1 **802.3da EEE Support Draft Text**
2 **12 July 2023 - Berlin**

Figure 147-3--PCS reference diagram

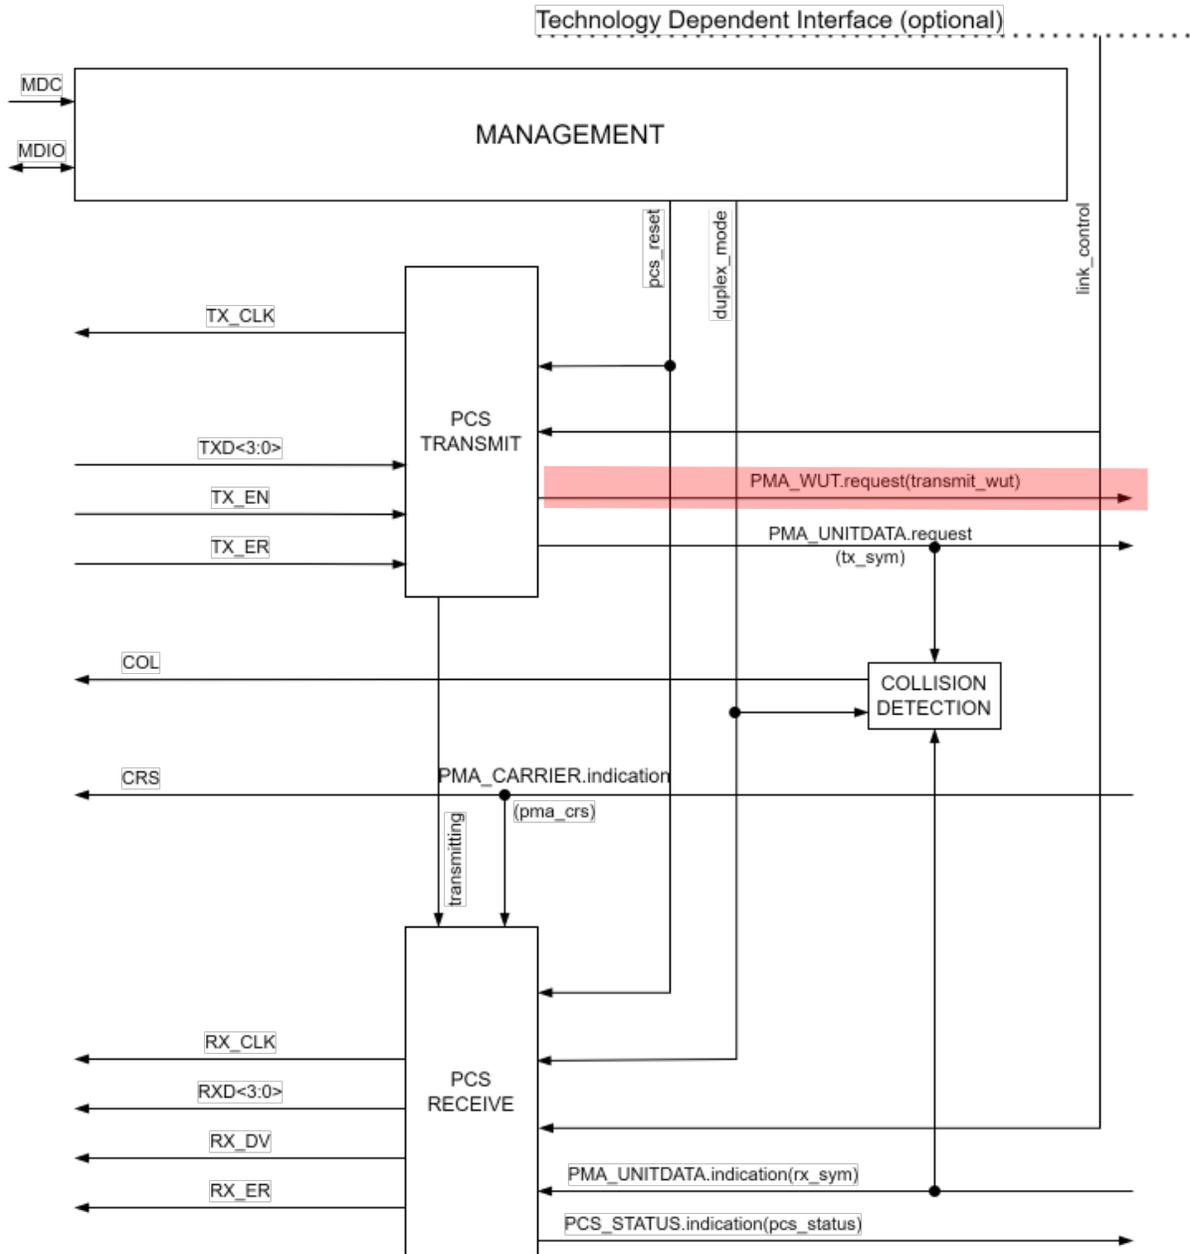
25 *Replace figure 147-3 with the following.*

Figure 147-7--PCS Receive state diagram, part a

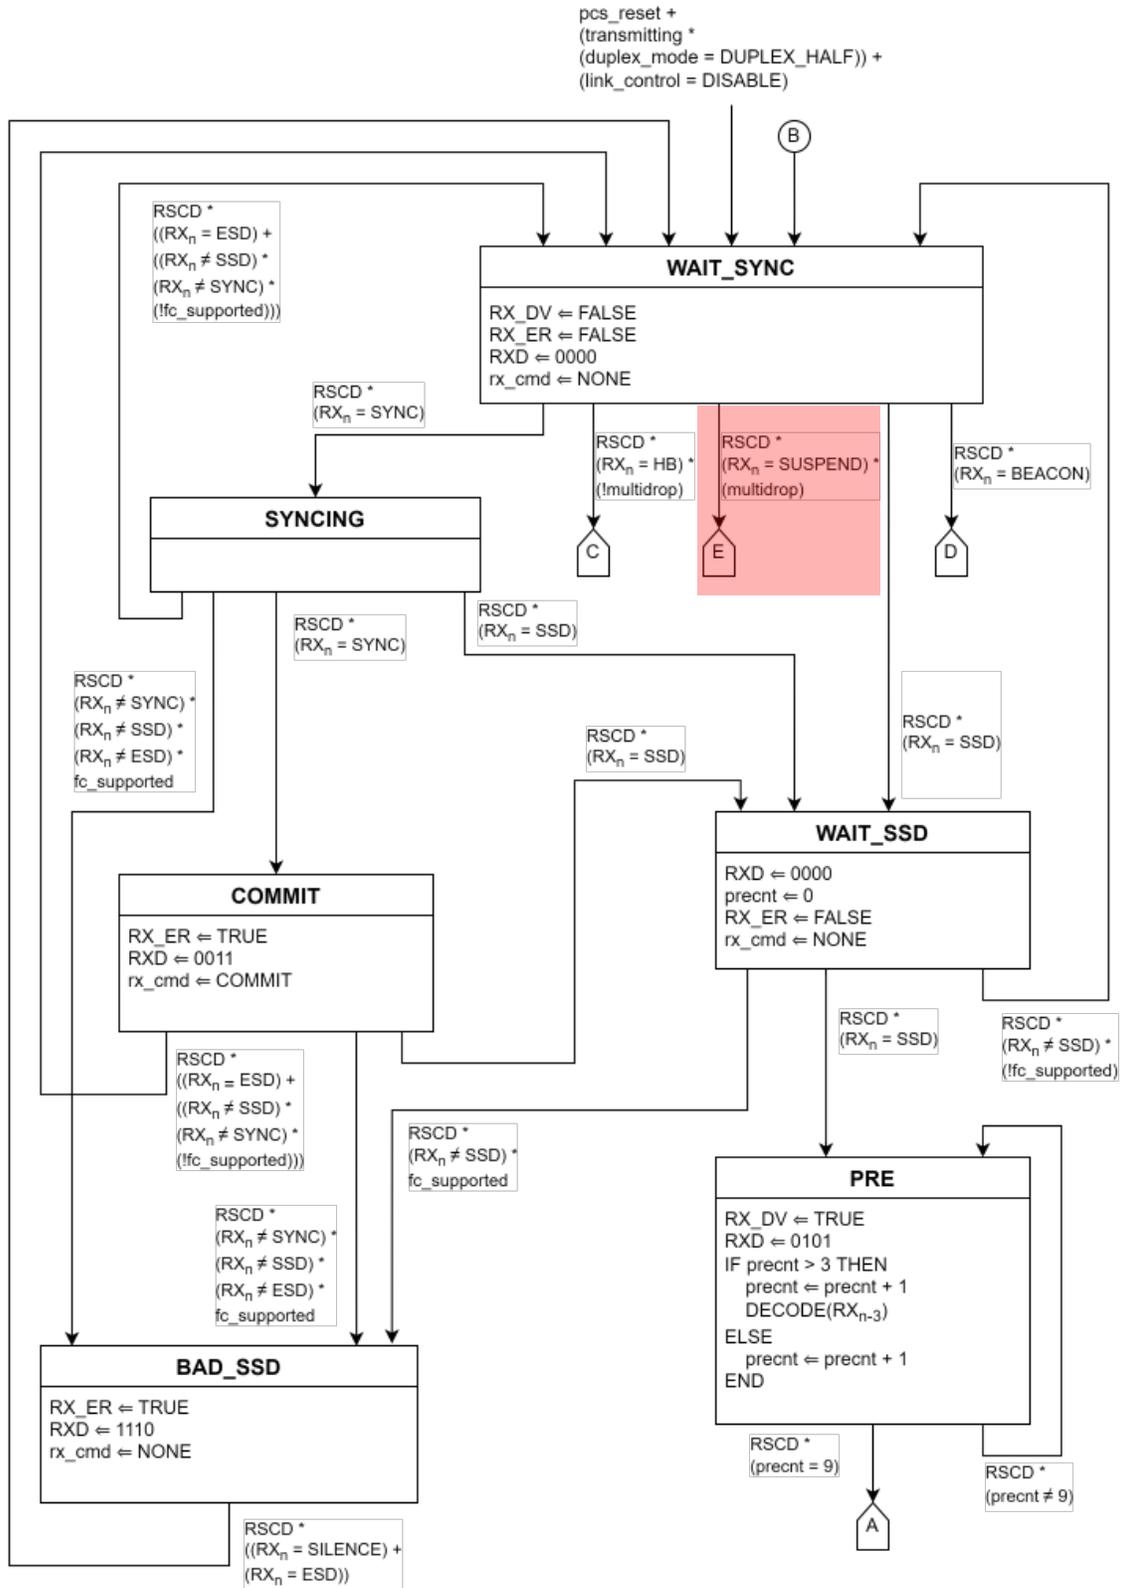
13 *Add the additional exit path from the WAIT_SYNC state of PCS Receive state diagram, part a (Figure 147-7) as shown.*

Figure 147-8--PCS Receive state diagram, part b

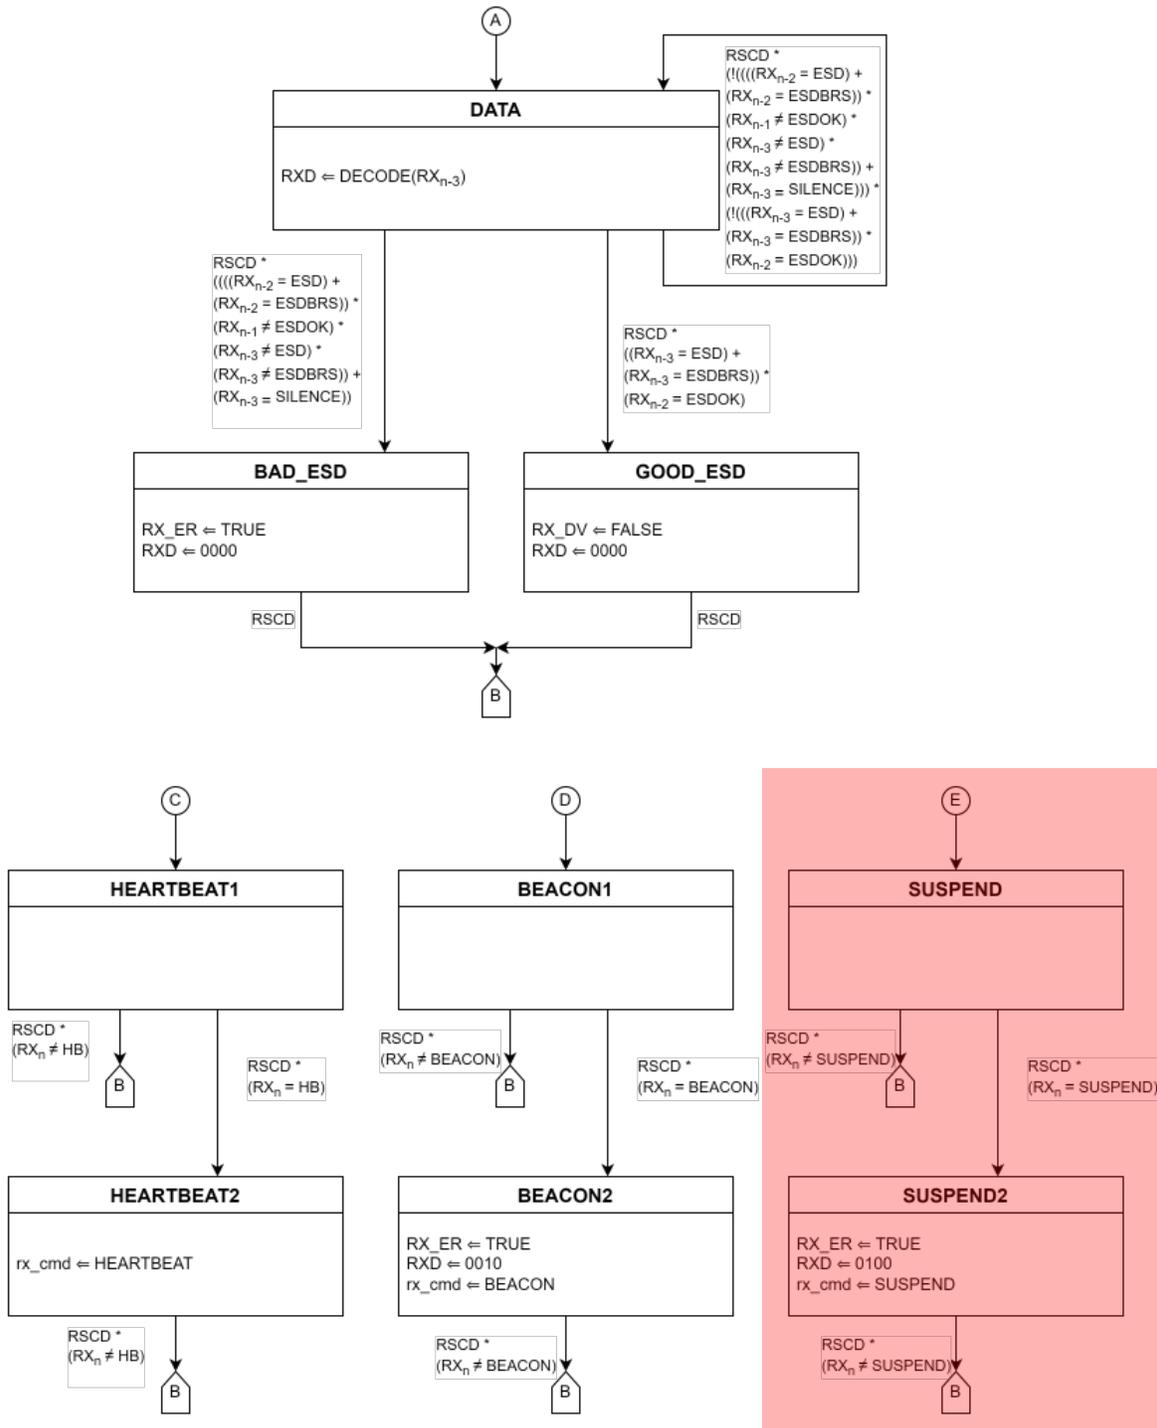
1 Add the additional SUSPEND and SUSPEND2 states to PCS Receive state diagram, part b (Figure 147-8) as shown.

Figure 147-12--PMA functional block diagram

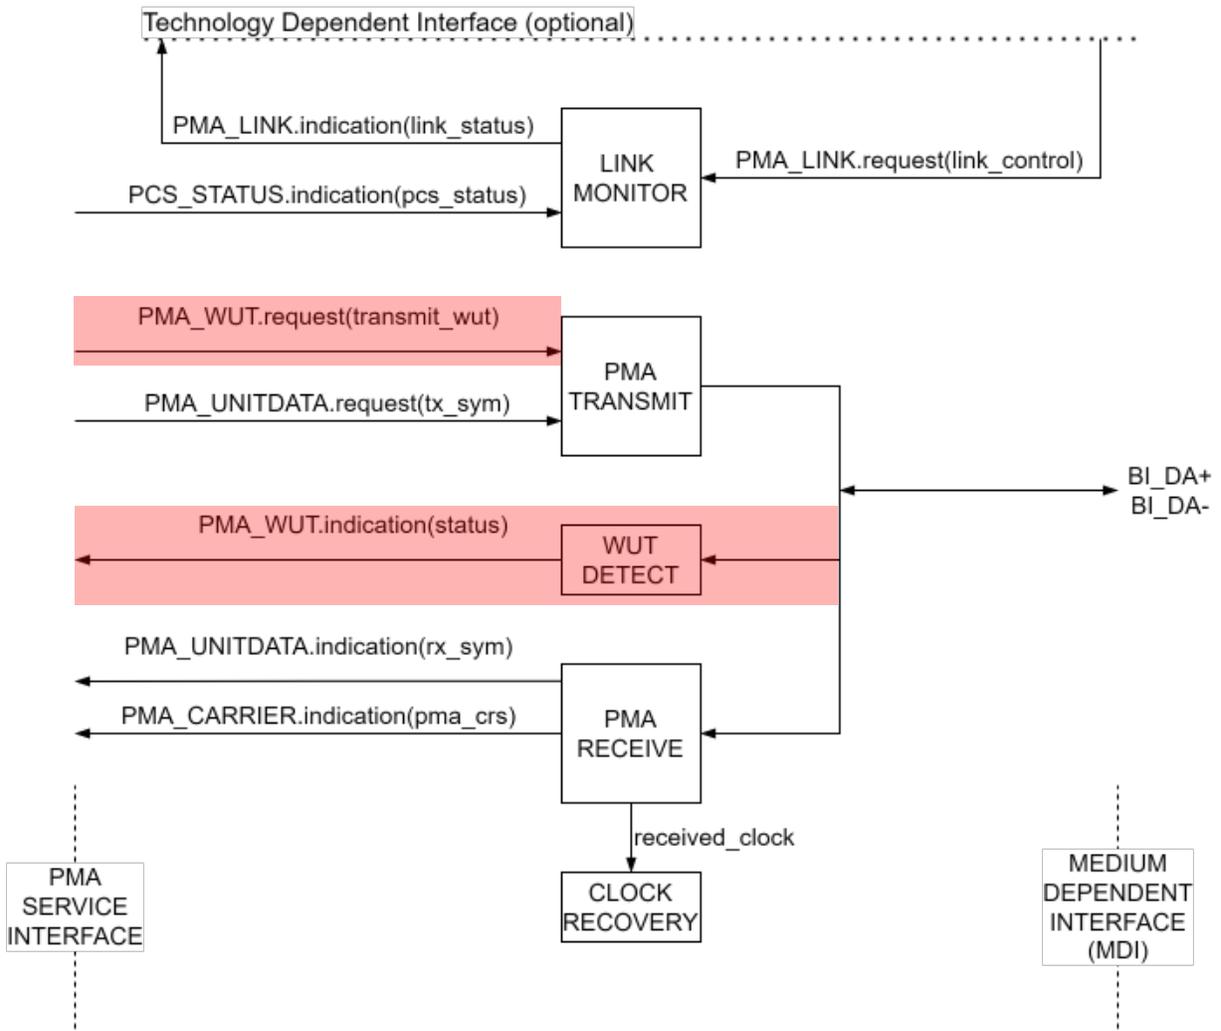
4 Replace PMA functional block diagram Figure 147-12 as below:

Figure 148-4--PLCA Control state diagram, part b

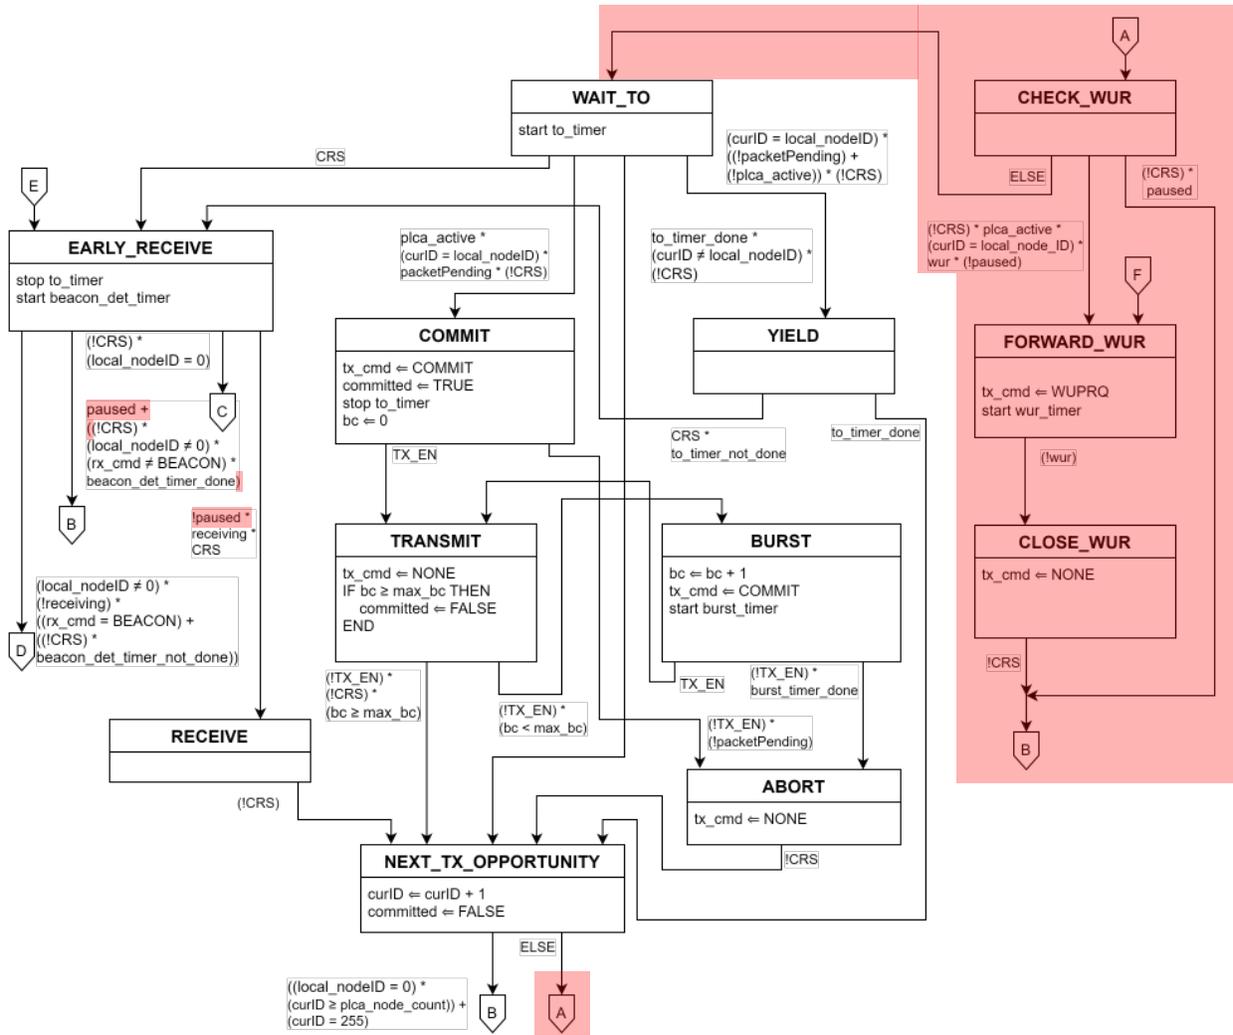
6 *Update Figure 148-3 and 148-4 with the following.*

Figure 148-5—PLCA Data state diagram, part a

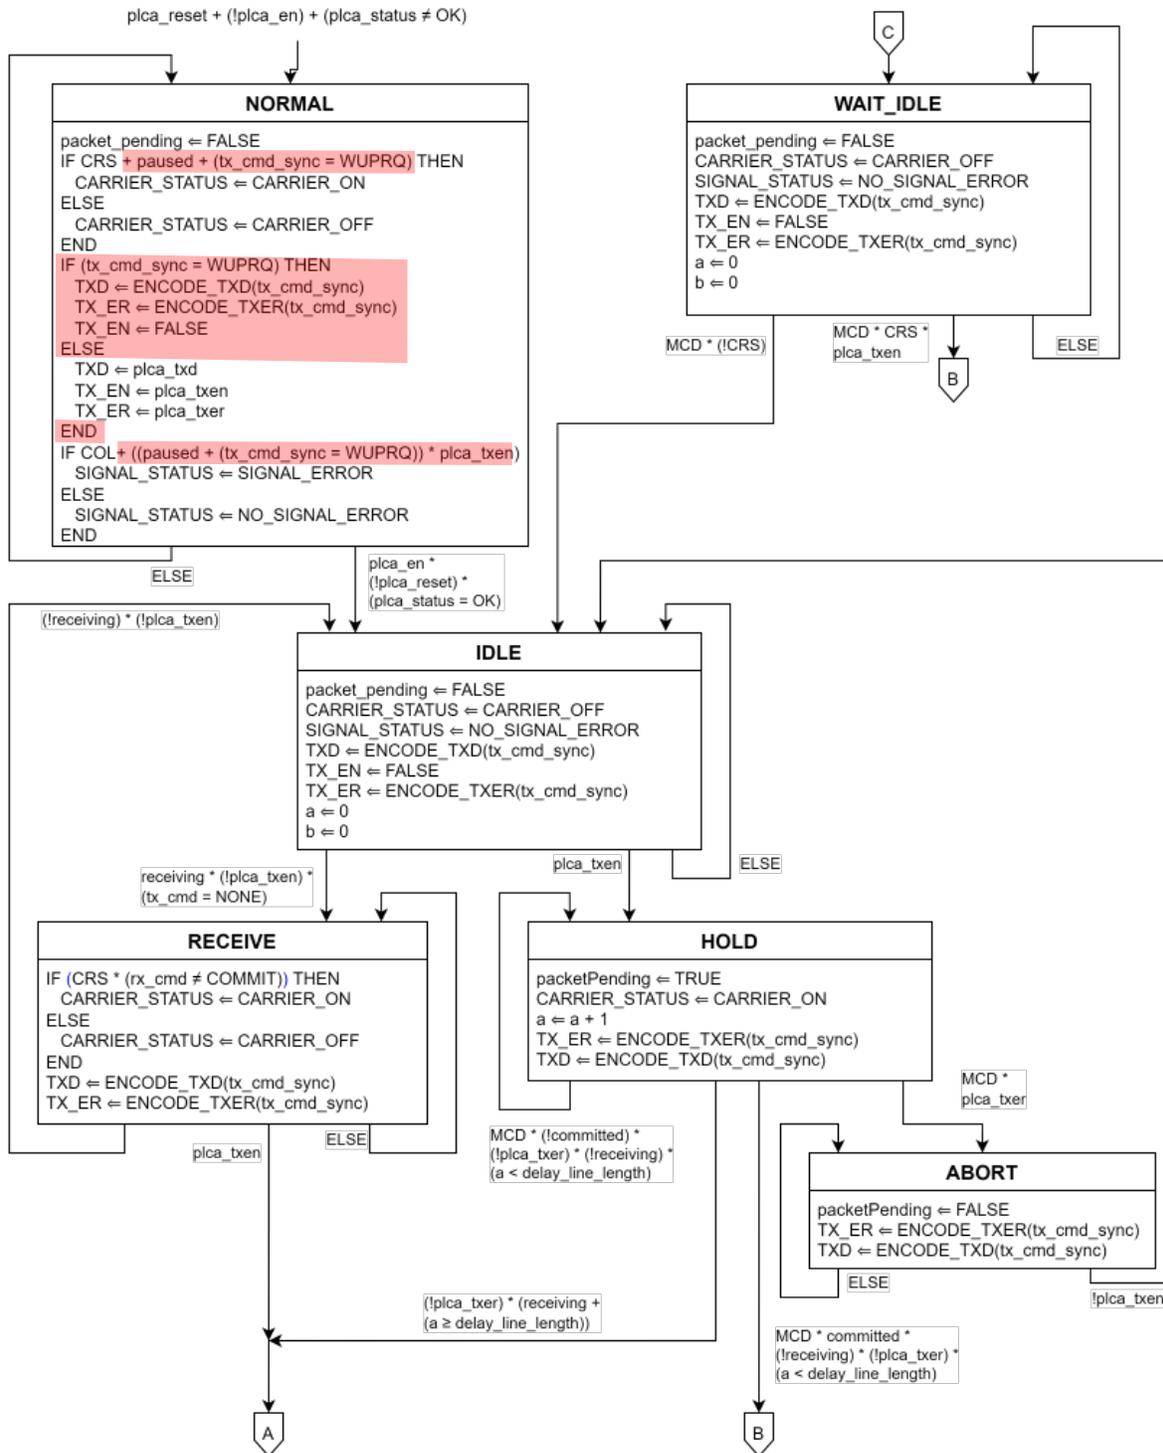
5 Update Figure 148-5—PLCA Data state diagram, part a with this one.
